CLIENT  
**BOURNE LEISURE**

PROJECT  
**BUTLINS 2021 SEASON**

DRAWING TITLE  
**Bognor Car Park Works  
Car Park Operation Plan**

DRAWING NO. 2014 WOO-MPN-BOG-DR-A-0010  
REVISION **C**

**1** Car Park Overlay  
1:500

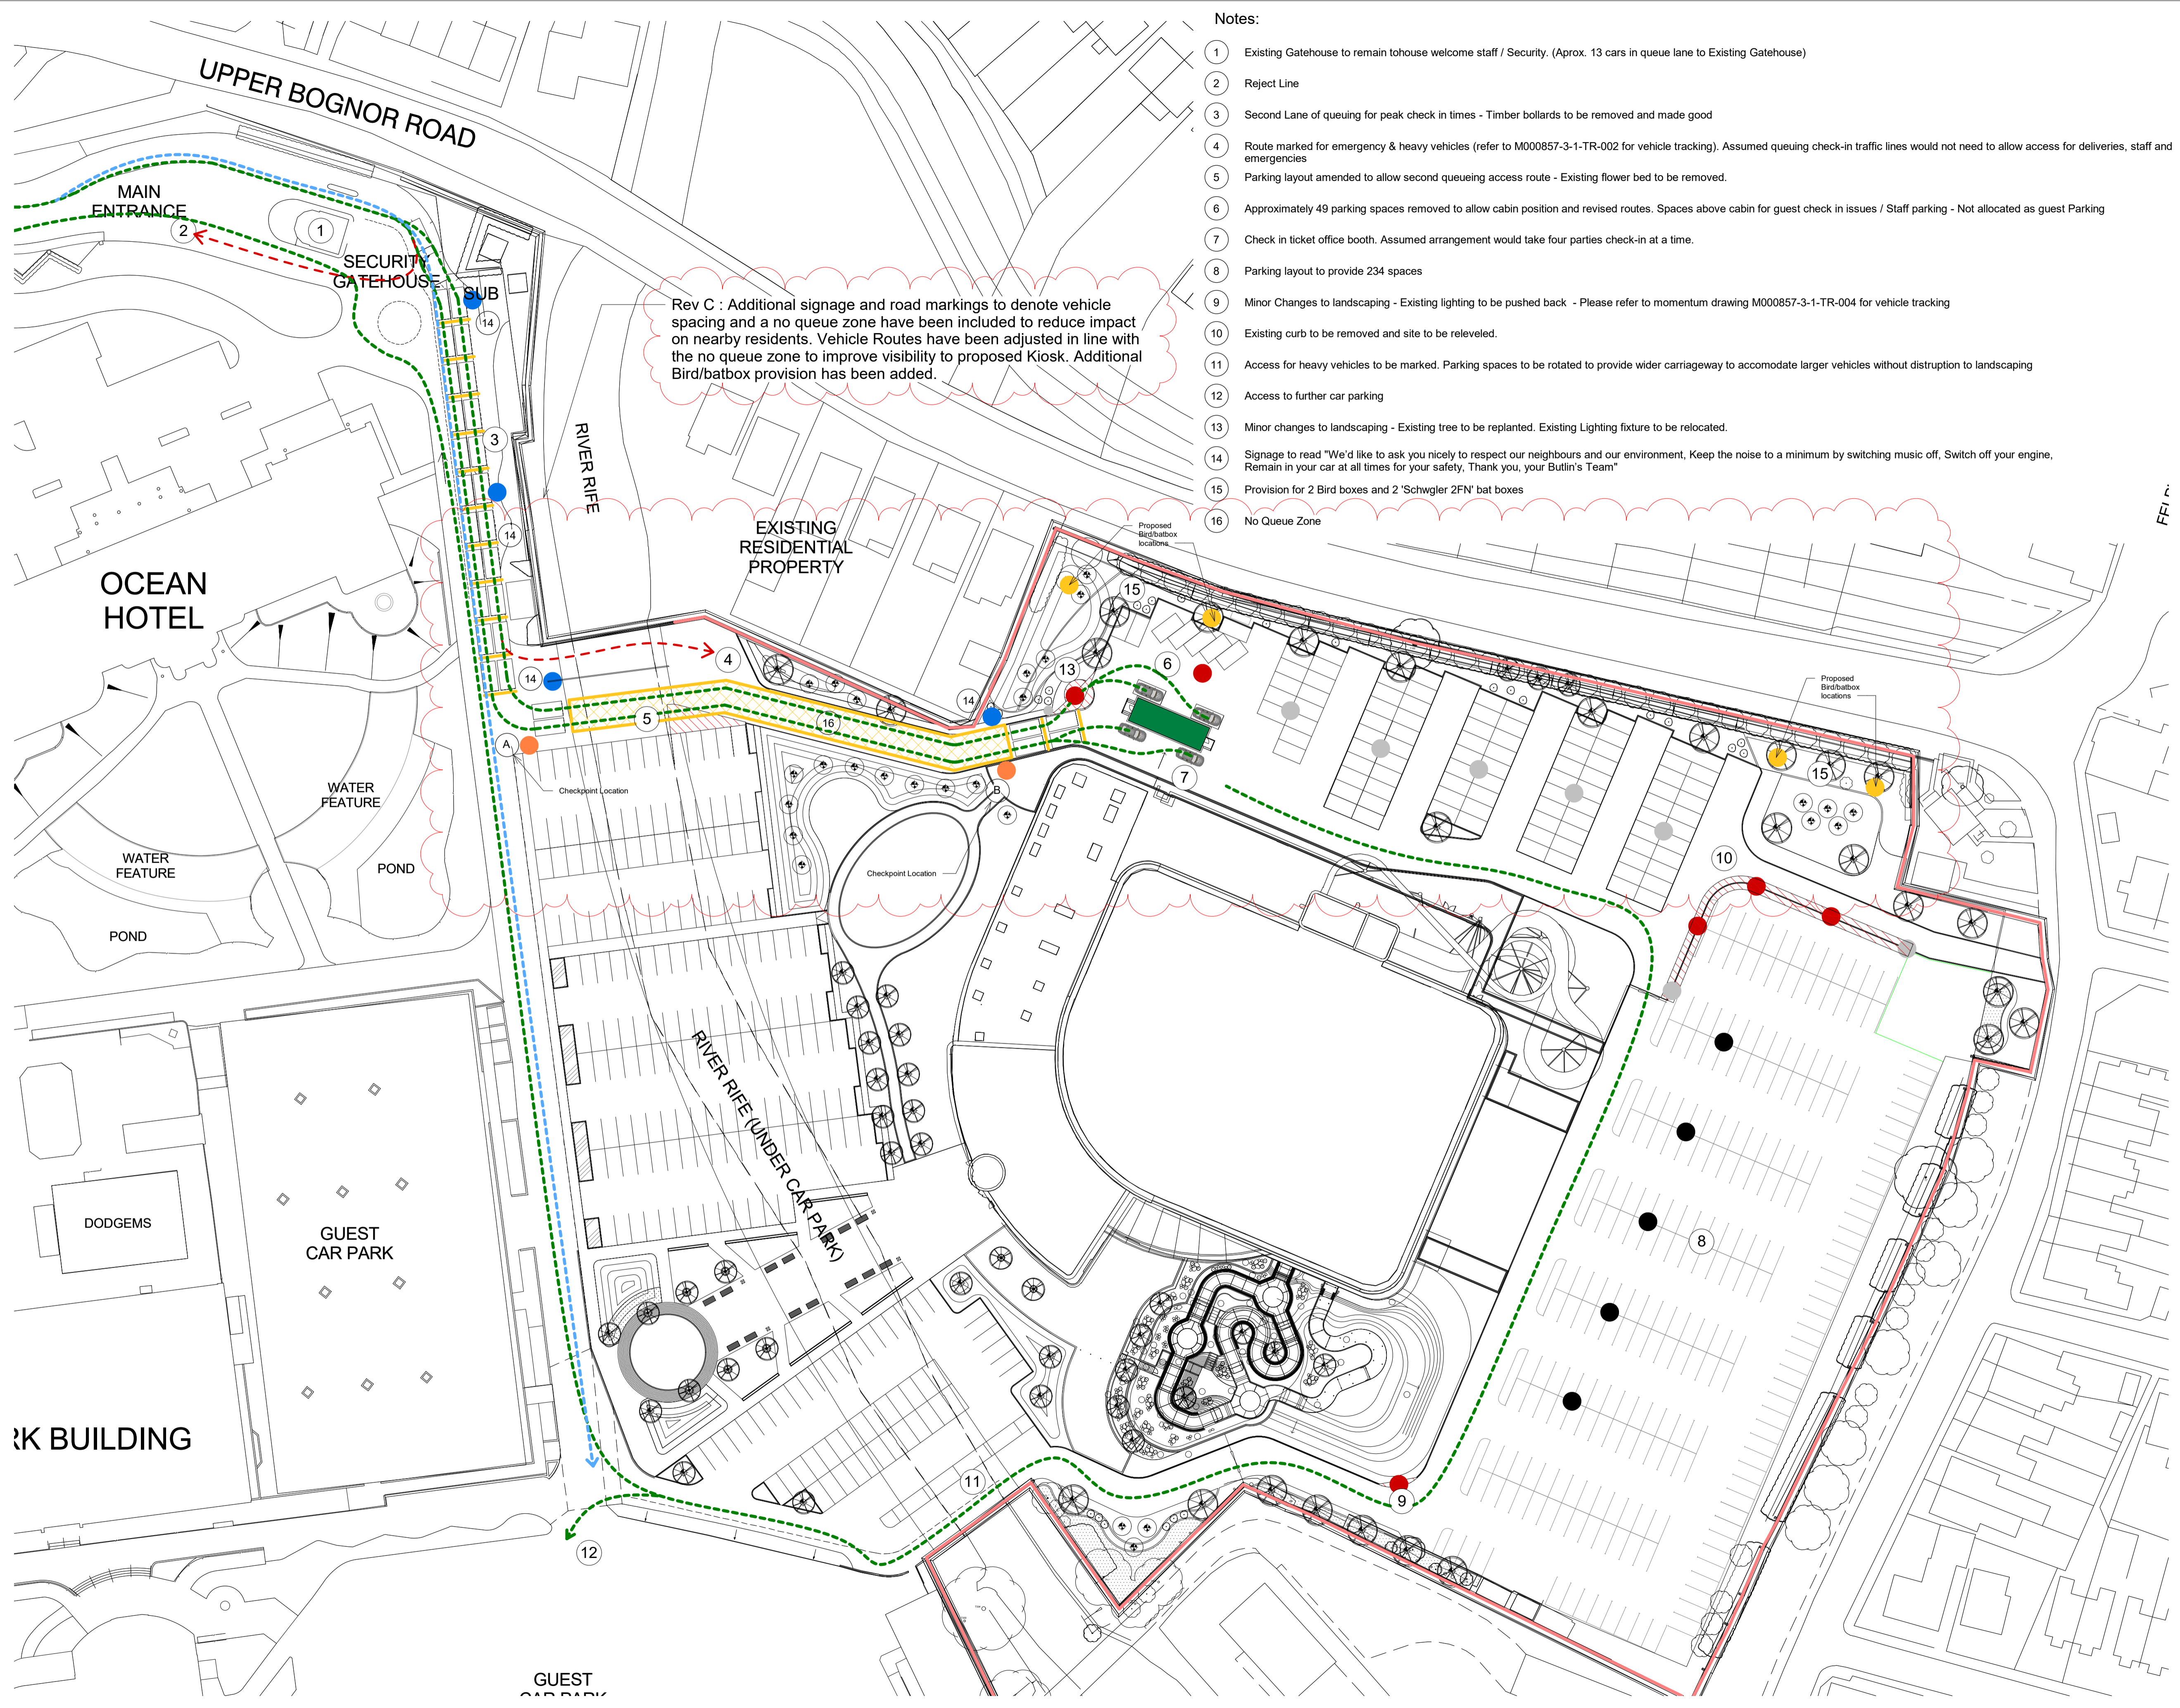
Rev C : Additional signage and road markings to denote vehicle spacing and a no queue zone have been included to reduce impact on nearby residents. Vehicle Routes have been adjusted in line with the no queue zone to improve visibility to proposed Kiosk. Additional Bird/batbox provision has been added.
